RE: Geotechnical Plan Review of 287 Tuhirangi Road, Makarau, Auckland
(Our Reference: 13704.000.001_02)

ENGEO Ltd was requested by Terra Group NZ Limited (Terra) on behalf of Raymond O'Brien and Victoria Pichler to provide a geotechnical review of the proposed Range Isopach Plan by Terra Group NZ Ltd (project number: 23406, drawing number: CP-200, rev: A, received 27 April 2017 for the NZ Shooting Sports Centre. This plan is included at the rear of this report as Attachment 1.

Proposed Range Isopach Plan

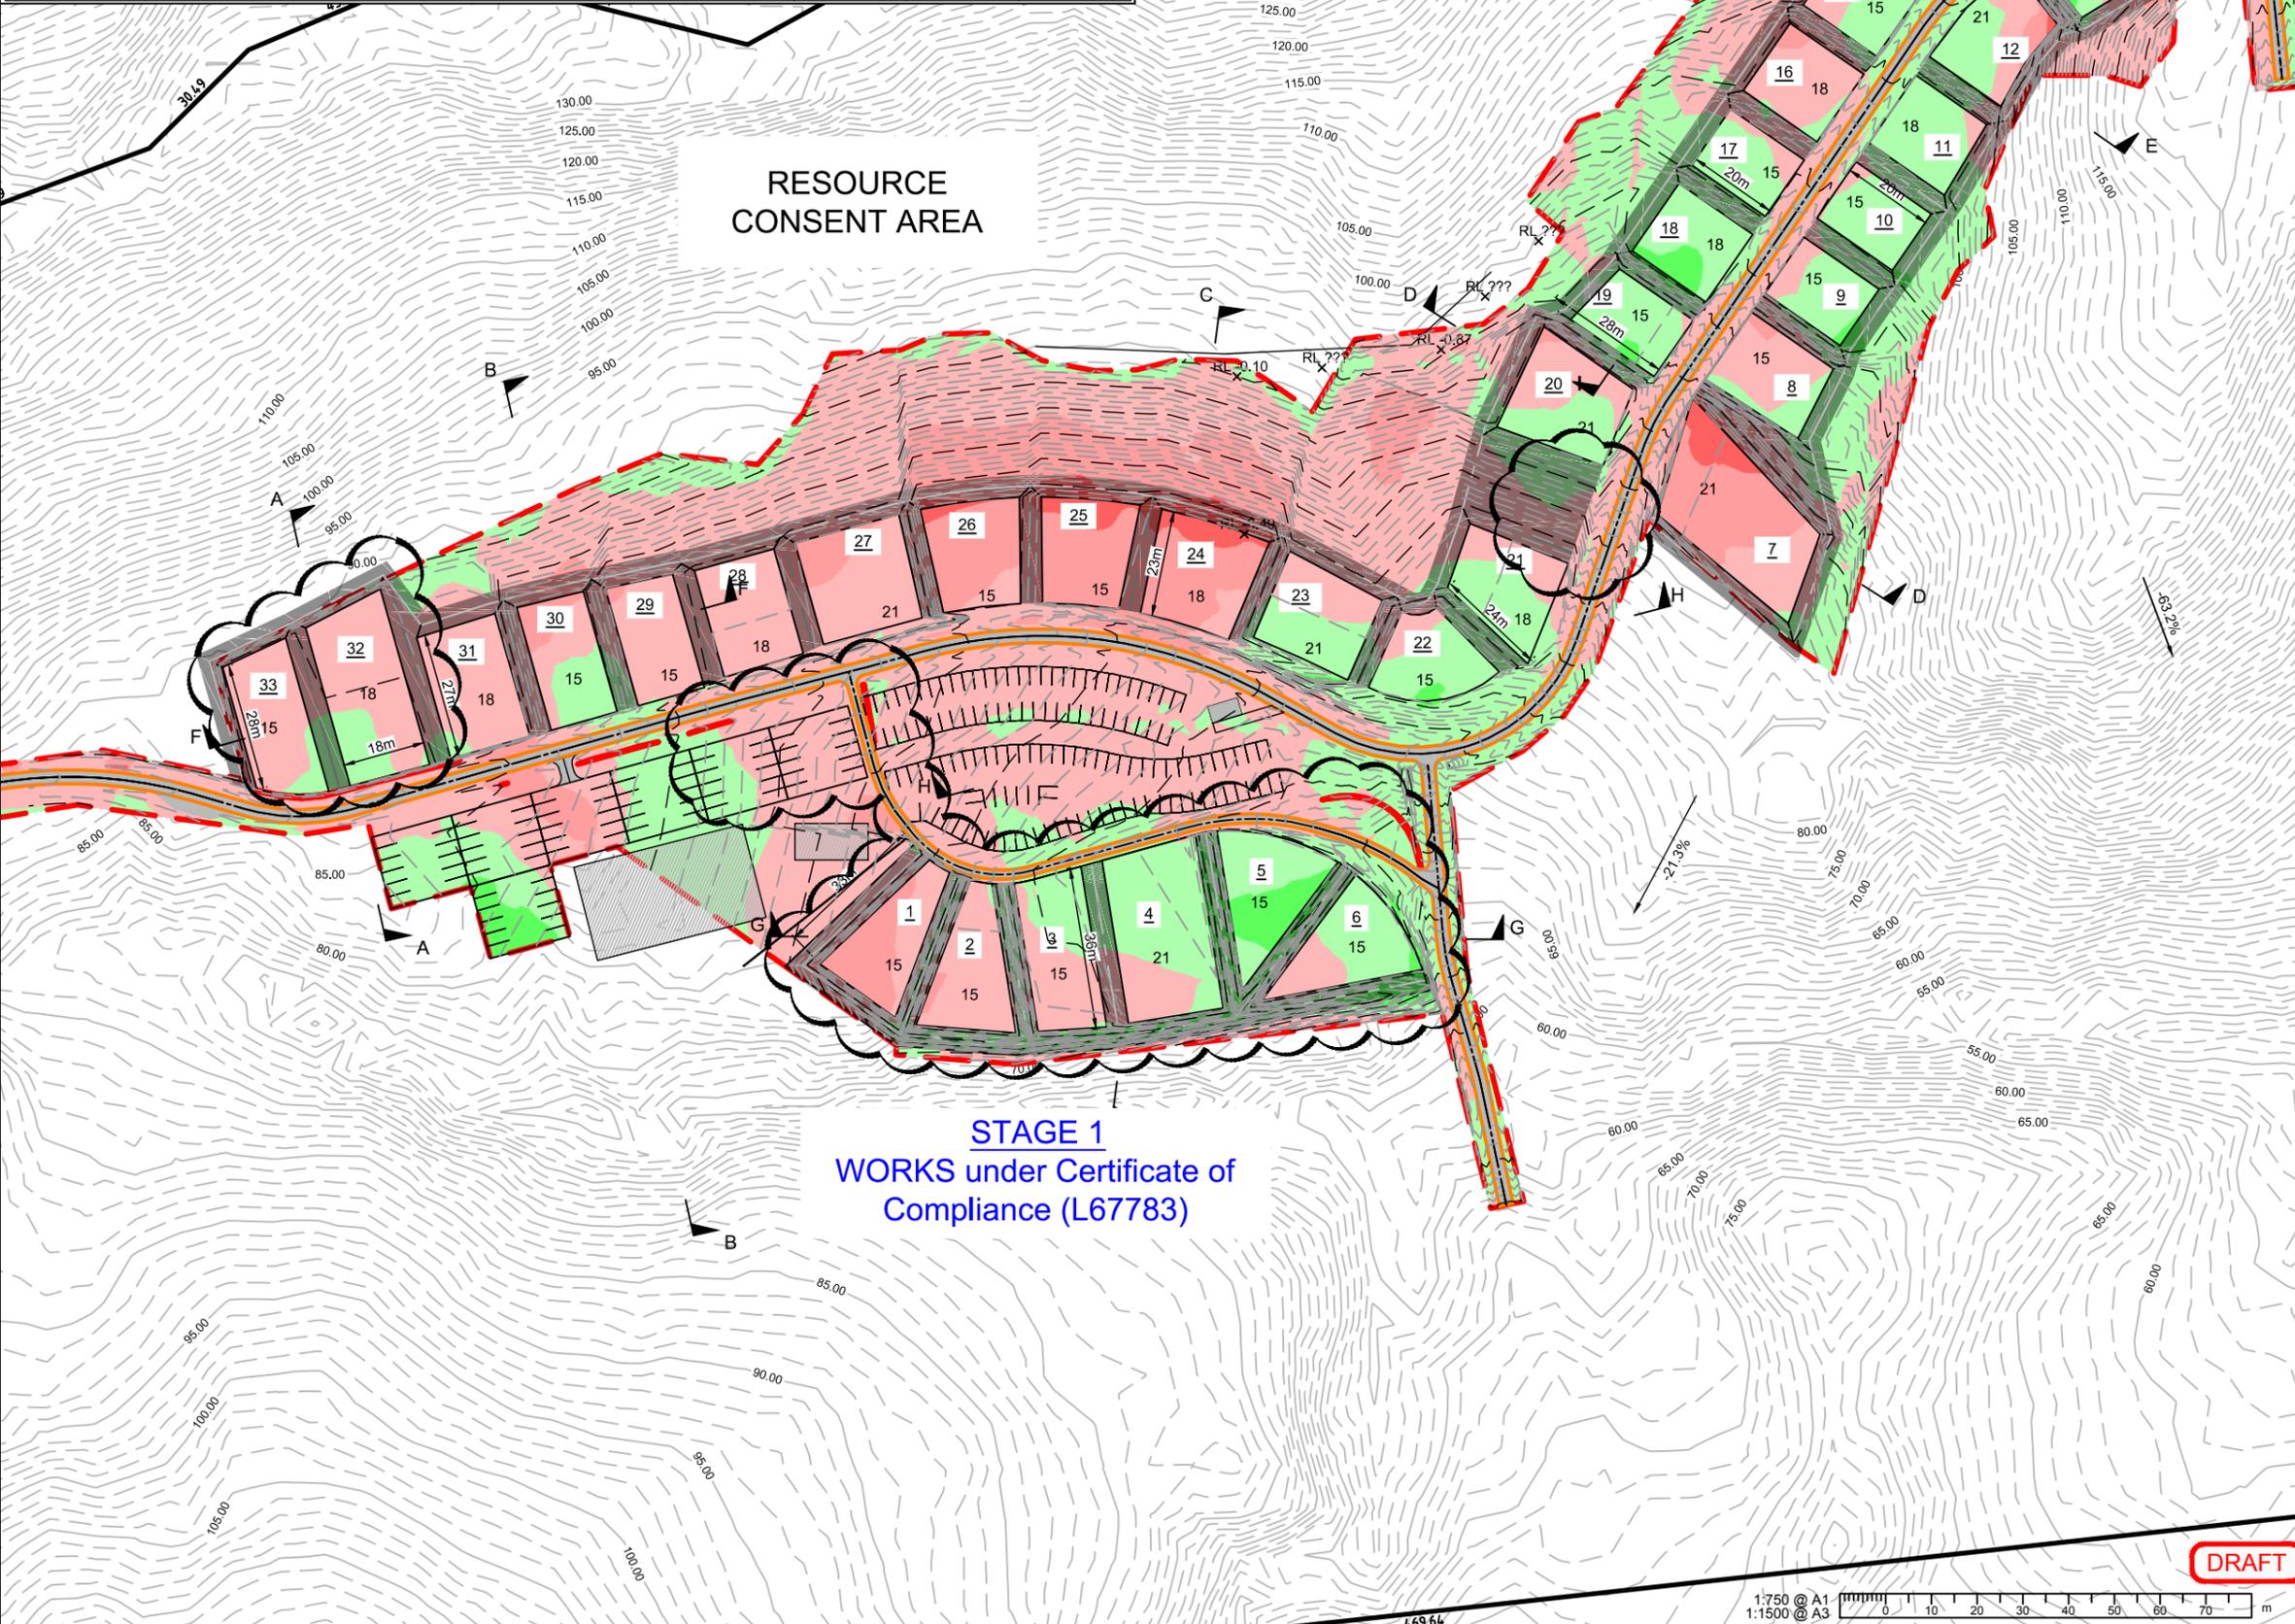
- 33 new shooting bays are to be constructed ranging from 20 m to 36 m in length;
- Two new carparks covering approximately 47,000 m²;
- Anticipated 68,000 m³ of cut and 22,000 m³ of fill, with cut and fill thicknesses varying from up to 12 m and 9 m across the site, respectively. The greatest volume of fill is to be placed in the northeast corner of the site, and the greatest volume of cut is located between shooting bays 24 and 26;
- Removal of material at the base of the slope at the back of the northern shooting bays 23 to 30. The proposed cut slopes range from 12° to 25°; and

- Removal of material at the base of the slope at the back of the northern shooting bays 15, 16 and 12 in the northeast corner of the site. The proposed cut slopes range from 20° to 55°.

Based on our past site investigation and observations, and review of the proposed Range Isopach Plan by Terra Group NZ Ltd (project number: 23406, drawing number: CP-200, rev: A, received 27 April 2017), we consider the site to be generally suitable for the proposed development. We recommend further geomorphic and slope stability assessment of the slopes located adjacent to shooting bays 23 to 28, as the proposed cut in this location is significant and there is a risk that the cut may destabilise the toe of the slope.

Due to the geological setting of the site and restrictions with access for further investigations at present, it is our opinion that the risk of instability along shooting bays 12, 15 and 16, and 23 to 28 is unable to be adequately quantified until earthworks are well underway and access to the cut area is made possible.

We recommend that additional geotechnical assessments be conducted during the earthworks to further develop the ground model and complete computer slope stability analyses. This will enable us provide recommendations during construction for earthworks modifications and / or slope retaining measures where required.

- All cuts greater than 1.5 m in soil or rock should be supported with a specifically designed retaining wall or properly keyed and benched into native ground and will need to be approved by a Chartered Professional Engineer practising in Geotechnical Engineering;
- For planning purposes, unsupported, finished slope grades should be no steeper than 1 Vertical to 2: Horizontal (26 degrees from horizontal) in soil;
- All excavated soil should be removed from site or placed in an engineered stockpile that is strategically placed such that would not trigger slope instability. If there is any soil to be placed permanently on site, we suggest contacting ENGEO for further guidance; and
- Any proposed earthworks and drainage plans should be approved by a suitably qualified Geotechnical Engineer familiar with both the site and the recommendations within this report for review and comment.
